Request for Additional Information No. 34 Supplement 1, Revision 0

U. S. EPR Standard Design Certification

AREVA NP Inc.

Docket No. 52-020

Figure 15.02.01-15.02.05-4-1—Turbine Trip – Representative Plot of the Key Parameters to DNBR Normalized to Initial Value

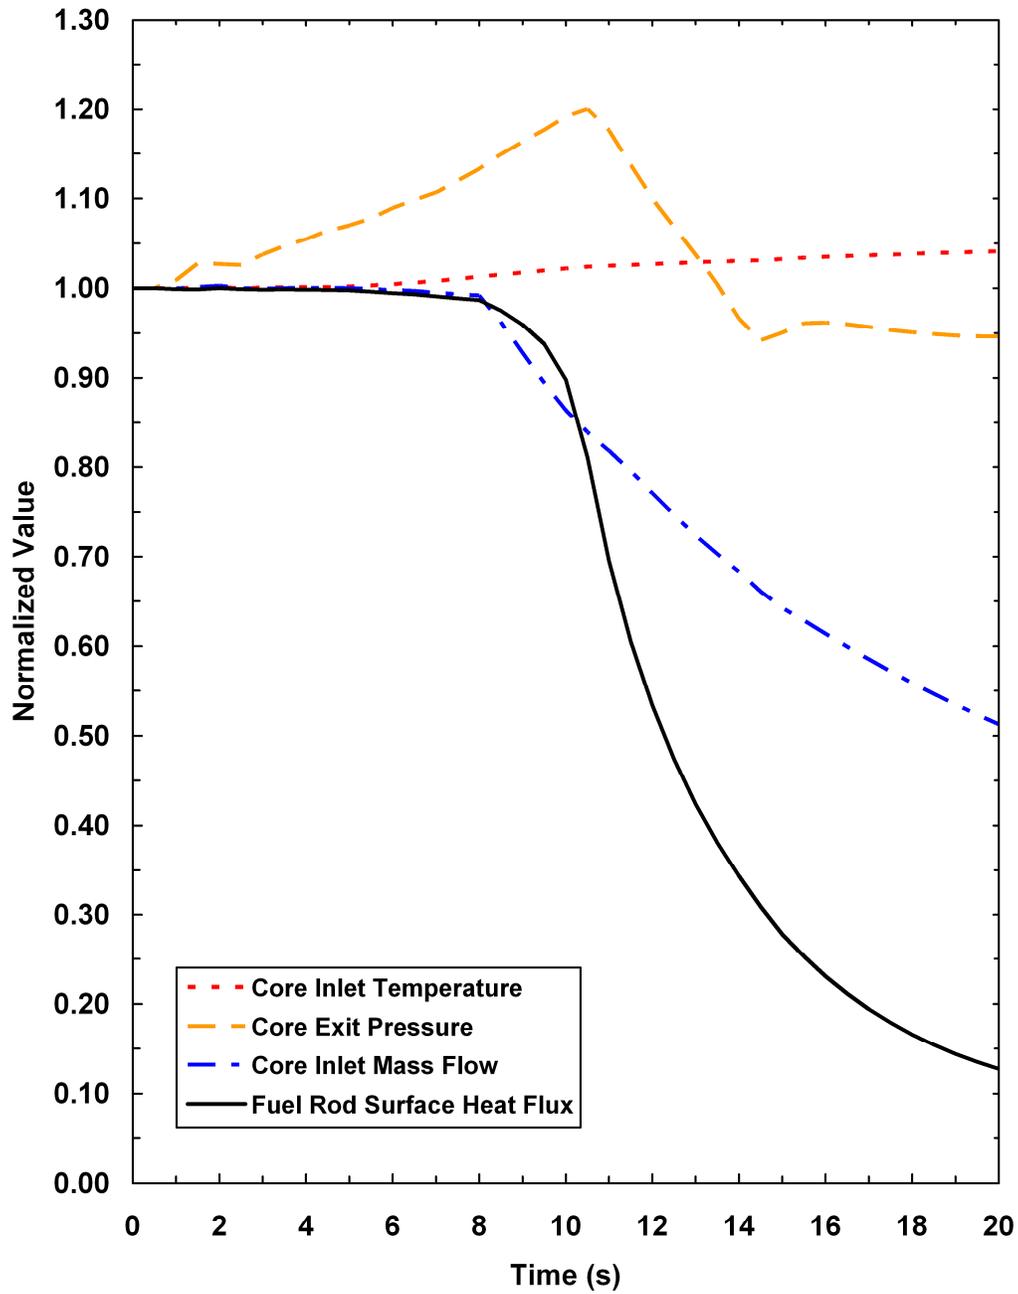
Please provide the minimum DNBR as a function of time.

The TT event is used to provide an evaluation of DNBR for these events. Because of the fast closure of the turbine stop valve, there is neither increase in the reactor coolant pump (RCP) speed nor flow that occurs in the LOEL event due to the temporary increase in turbine generator (TG) speed.

For the TT transient DNBR analysis, a qualitative evaluation is performed of the key parameters affecting DNBR up to the point of rod insertion due to a reactor trip (RT) on high pressurizer (PZR) pressure. The evaluation of these key parameters (including core inlet temperature, core exit pressure, core inlet mass flux, and fuel rod surface heat flux) concludes that the TT event is not a DNBR-limiting event. To support this conclusion, the key parameters affecting DNBR are shown in Figure 15.02.01-15.02.05-4-1—Turbine Trip – Representative Plot of the Key Parameters to DNBR Normalized to Initial Value. Each parameter has been normalized to its initial value so that the behavior of relevant parameters can be displayed in a single graph to provide a perspective on the magnitude of change that occurs in each parameter.

Figure 15.02.01-15.02.05-6-1—Single Main Steam Isolation Valve Closure – Representative Plot of Minimum DNBR Normalized to the DNBR SAFDL

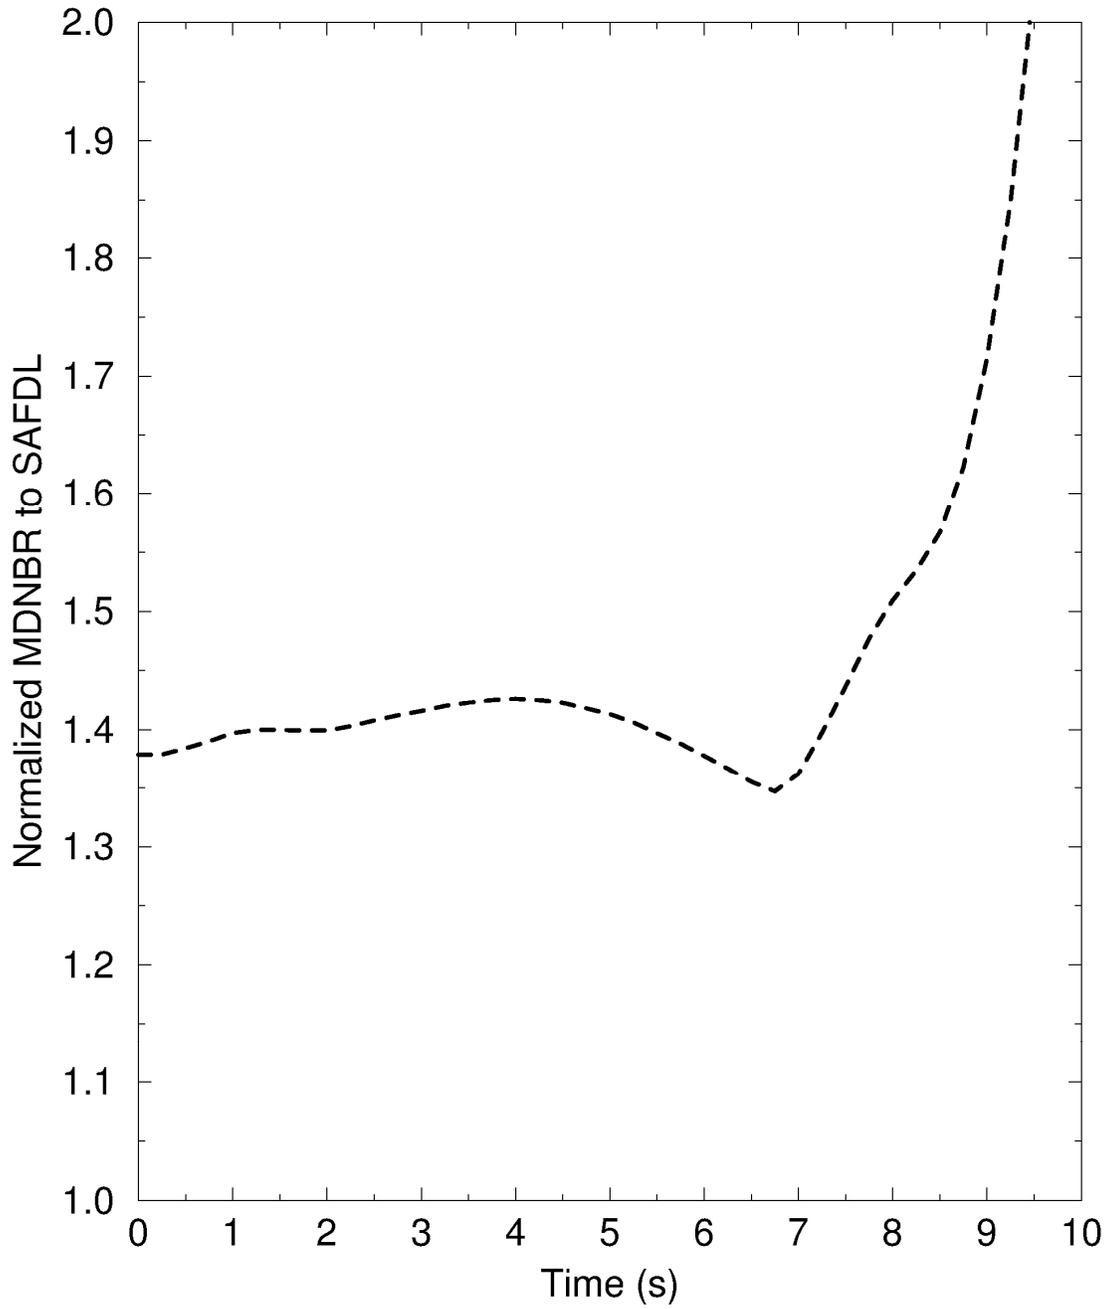
Section 15.2.4.3.2 DNBR analysis results do not provide the results of the DNBR calculation. Please provide a figure showing minimum DNBR as a function of time.

To support the conclusion in the U.S. EPR FSAR, Tier 2, Section 15.2.4.3.2, a representative minimum departure from nucleate boiling ratio (DNBR) as a function of time normalized to the DNBR specified acceptable fuel design limit (SAFDL) calculated by the low DNBR channel algorithm is provided in Figure 15.02.01-15.02.05-6-1—Single Main Steam Isolation Valve Closure – Representative Plot of Minimum DNBR Normalized to the DNBR SAFDL. This transient event is not limiting with respect to departure from nucleate boiling (DNB) or linear power density (LPD) and does not incur an incore trip.

Figure 15.02.07-1-1—Loss of Normal Feedwater Flow – Representative Plot of Minimum DNBR Normalized to the DNBR SAFDL

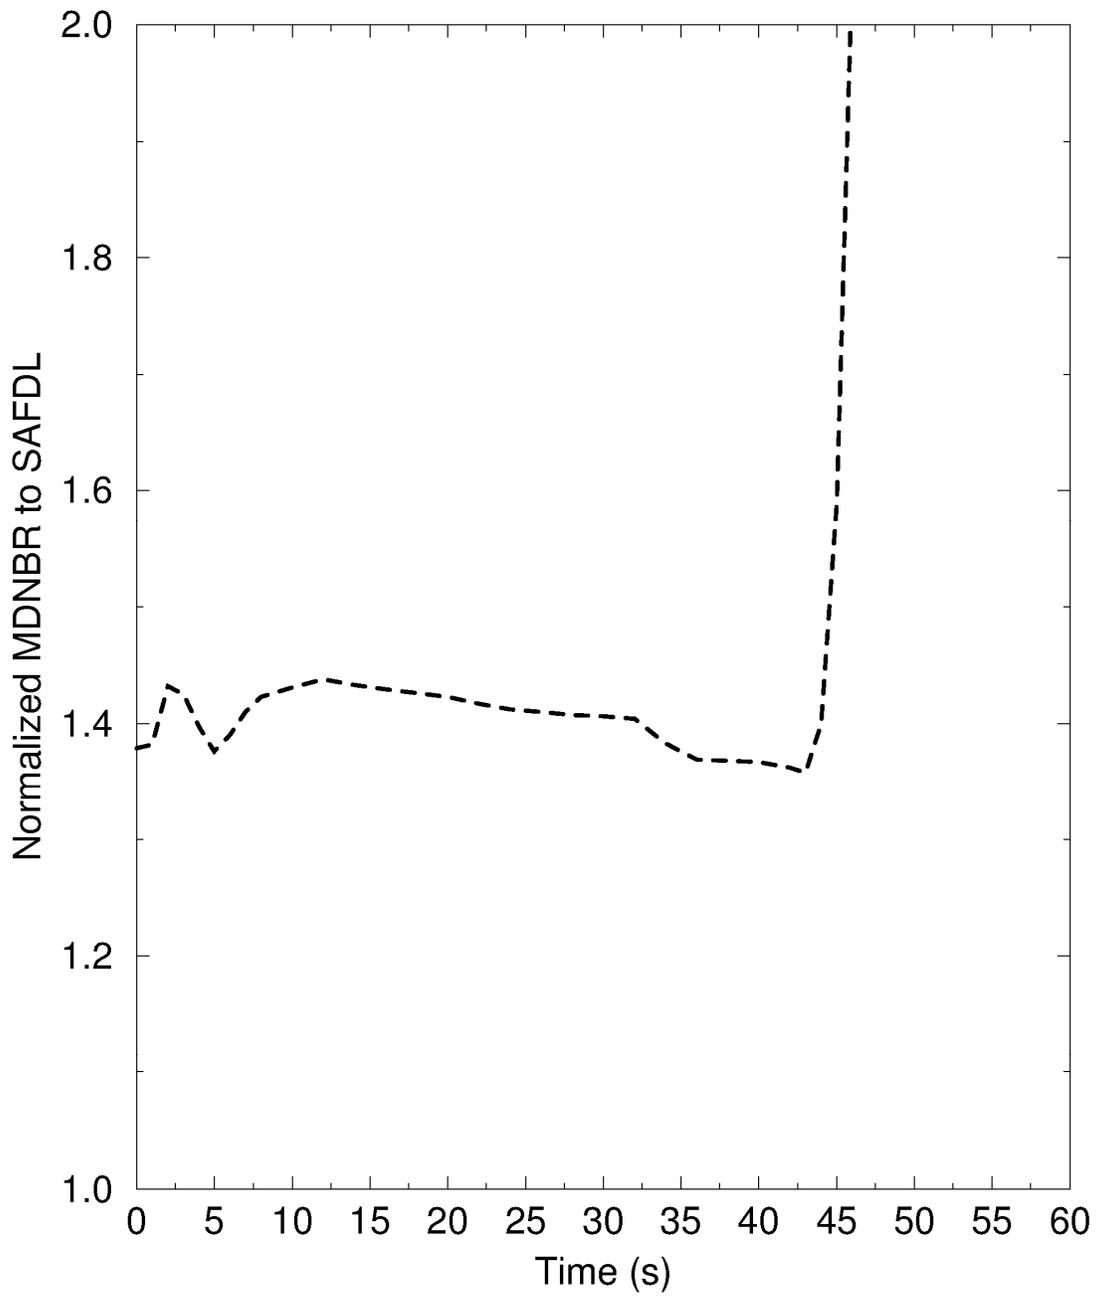
Please provide a figure showing minimum DNBR as a function of time for this event.

A representative minimum departure from nucleate boiling ratio (DNBR) as a function of time normalized to the DNBR specified acceptable fuel design limit (SAFDL) calculated by the low DNBR channel algorithm is provided in Figure 15.02.07-1-1—Loss of Normal Feedwater Flow – Representative Plot of Minimum DNBR Normalized to the DNBR SAFDL. This transient event is not departure from nucleate boiling (DNB) or linear power density (LPD) limiting and does not incur an incore trip.

Figure 15.02.08-2-1—Feedwater Piping Break Inside and Outside Containment – Representative Plot of Minimum DNBR Normalized to the DNBR SAFDL.

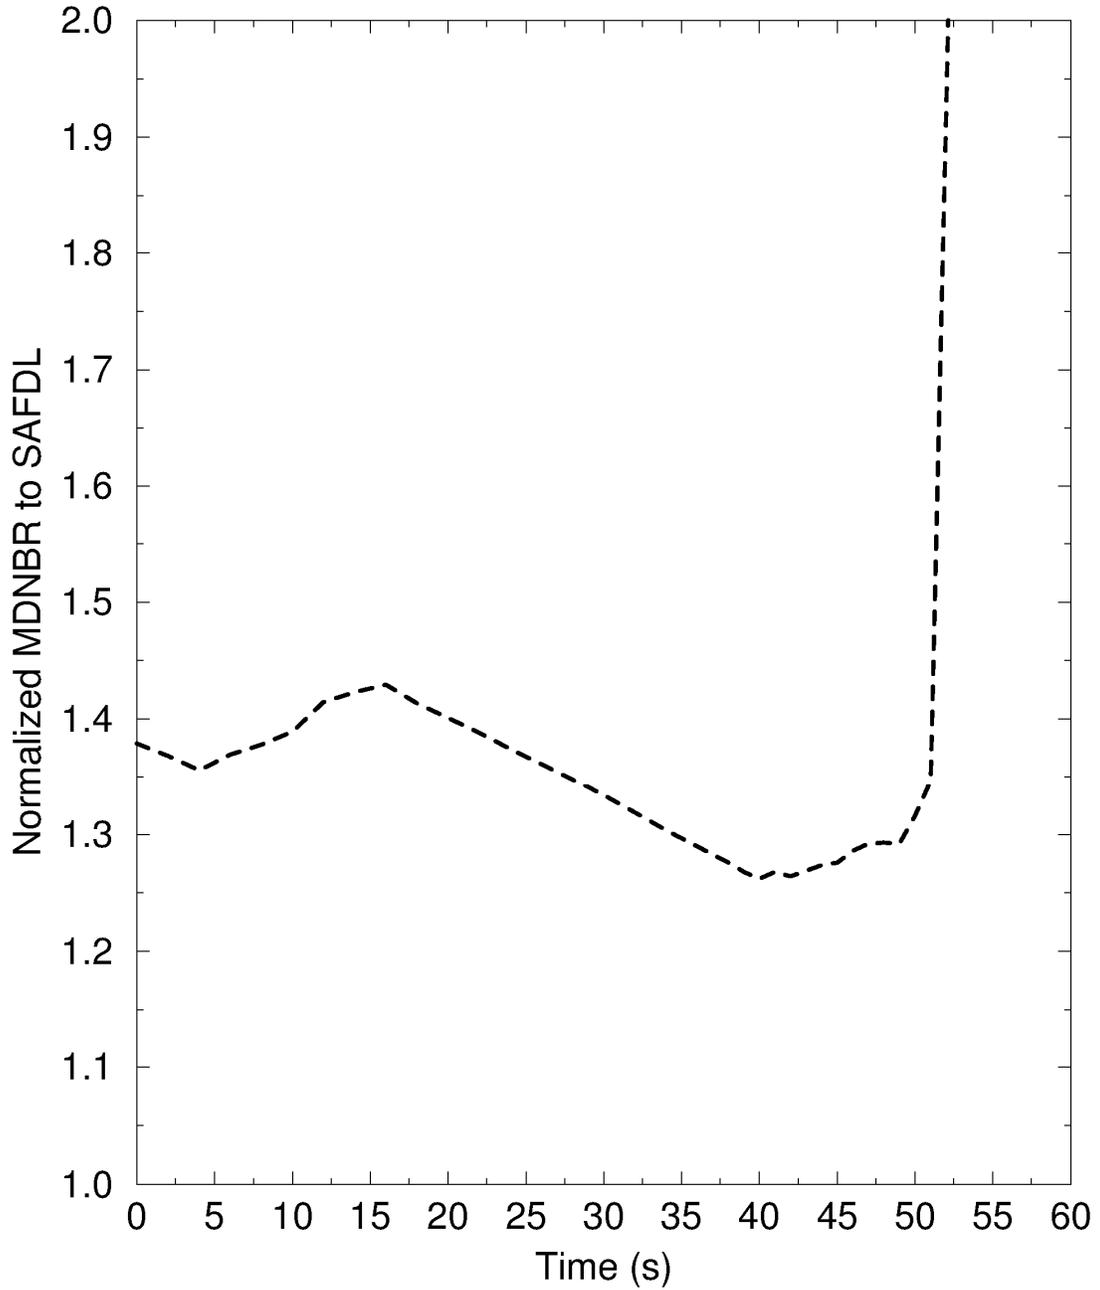
Provide data of calculated transient DNBR and amount of fuel failures to support the evaluation of the acceptance criteria for this event as stated in Section 15.2.8.2 of the FSAR.

To support the statements in the U.S. EPR FSAR, Tier 2, Section 15.2.8.2 for the scenarios that cause a cold leg heatup, a representative minimum departure from nucleate boiling ratio (DNBR) as a function of time normalized to the DNBR specified acceptable fuel design limit (SAFDL) calculated by the low DNBR channel algorithm is provided in Figure 15.02.08-2-1—Feedwater Piping Break Inside and Outside Containment – Representative Plot of Minimum DNBR Normalized to the DNBR SAFDL. This transient event is not departure from nucleate boiling (DNB) or linear power density (LPD) limiting and does not incur an incore trip.

Figure 15.02.08-14-1—Reactivity Components for Turbine Trip Peak RCS Pressure Case

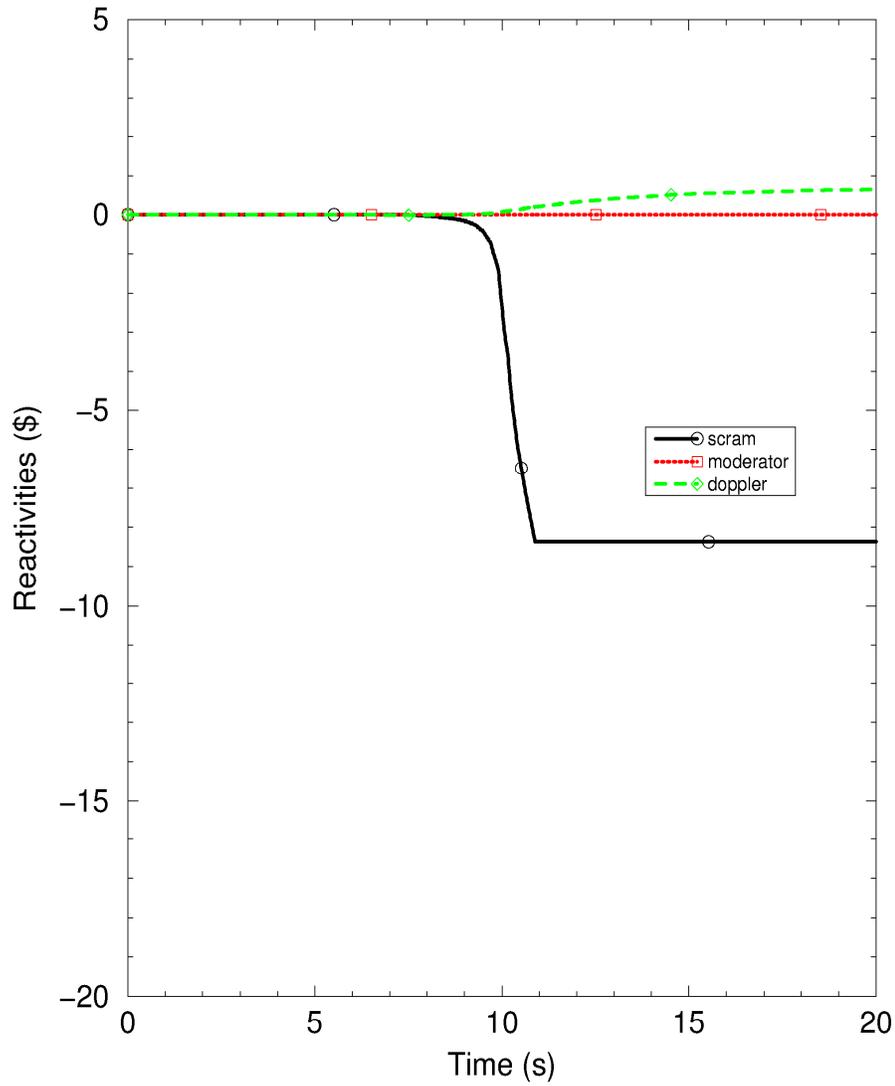
Provide, as function of time, all individual reactivity components used to compute the total reactivity parameters shown in Figures 15.2.5 and 15.2-22 (15.2.8 Section III).

The individual reactivity components used to compute the total reactivity parameters shown in U.S. EPR FSAR, Tier 2, Figure 15.2-5—Turbine Trip RCS Overpressurization - Total Reactivity and Figure 15.2-22—MSIVC Secondary Overpressurization—Total Reactivity are provided in Figure 15.02.08-14-1—Reactivity Components for Turbine Trip Peak RCS Pressure Case and Figure 15.02.08-14-2—Reactivity Components for MSIVC Peak Secondary Pressure Case, respectively.

Figure 15.1-57—Decrease in Feedwater Temperature - Representative Plot of Normalized Minimum DNBR and Maximum LPD to SAFDL

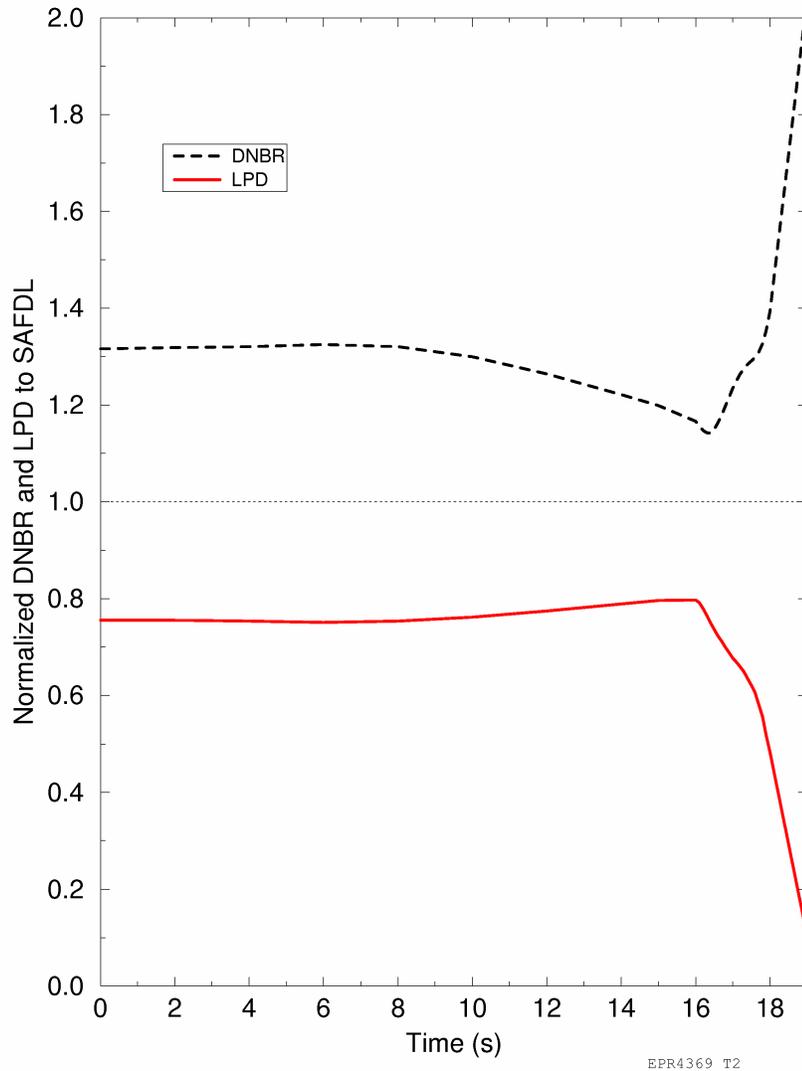
Provide the representative DNBR as a function of time for all Chapter 15.1 analyses for which it is a key parameter.

Representative plots of the minimum departure from nucleate boiling ratio (DNBR) and maximum linear power density (LPD) to their respective specified acceptable fuel design limits (SAFDLs) are shown on new U.S. EPR FSAR, Tier 2, Figures 15.1-57 through Figure 15.1-60. U.S. EPR FSAR, Tier 2, will also be revised to incorporate the description of these figures.

In the new figures, the line indicated as LPD is the calculated LPD normalized to either the fuel centerline melt (FCM) or clad strain limit (whichever is more limiting), including all applicable uncertainties. For anticipated operational occurrence (AOO) events, the limiting LPD of clad strain is more limiting and is therefore used to provide the normalized LPD. The LPD SAFDL is designed to protect both the FCM and clad strain limits as discussed in U.S. EPR FSAR, Tier 2, Section 15.0.0.3.9.

Figure 15.1-61—MSLB (small break, pre-scrum) - Representative Plot of Normalized Minimum DNBR and Maximum LPD to SAFDL

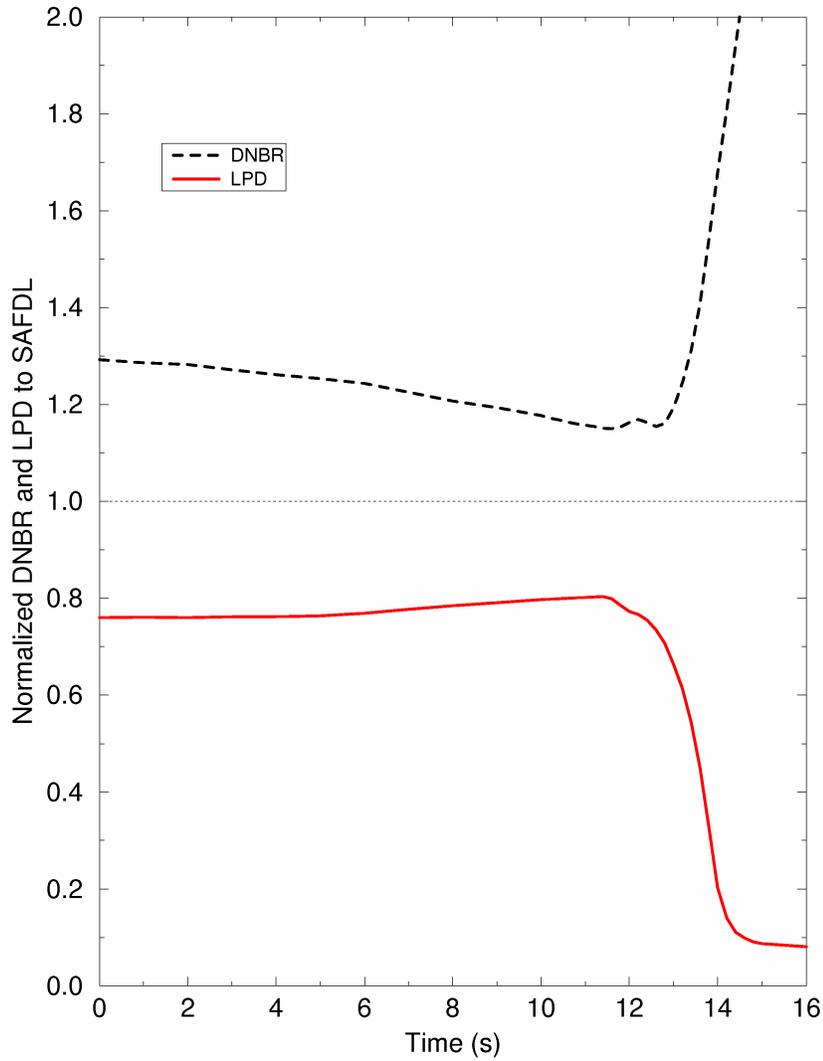
Please provide a discussion of the pre-scrum portion of the MSLB.

To support the small break, pre-scrum evaluation of the MSLB event, a representative plot of the normalized minimum departure from nucleate boiling ratio (DNBR) and maximum linear power density (LPD) to their respective SAFDL is provided in the enclosed new U.S. EPR FSAR, Tier 2, Figure 15.1-61—MSLB (small break, pre-scrum) – Representative Plot of Normalized Minimum DNBR and Maximum LPD to SAFDL.

The line indicated as LPD is the calculated LPD normalized to either the fuel centerline melt (FCM) or clad strain limits (whichever is more limiting), including all applicable uncertainties. For anticipated operational occurrence (AOO) events, the limiting LPD of clad strain is more limiting and is therefore used to provide the normalized LPD. The LPD SAFDL is designed to protect both the FCM and clad strain limits as discussed in U.S. EPR FSAR, Tier 2, Section 15.0.0.3.9. This applies only to the small break, pre-scrum portion of the MSLB event.
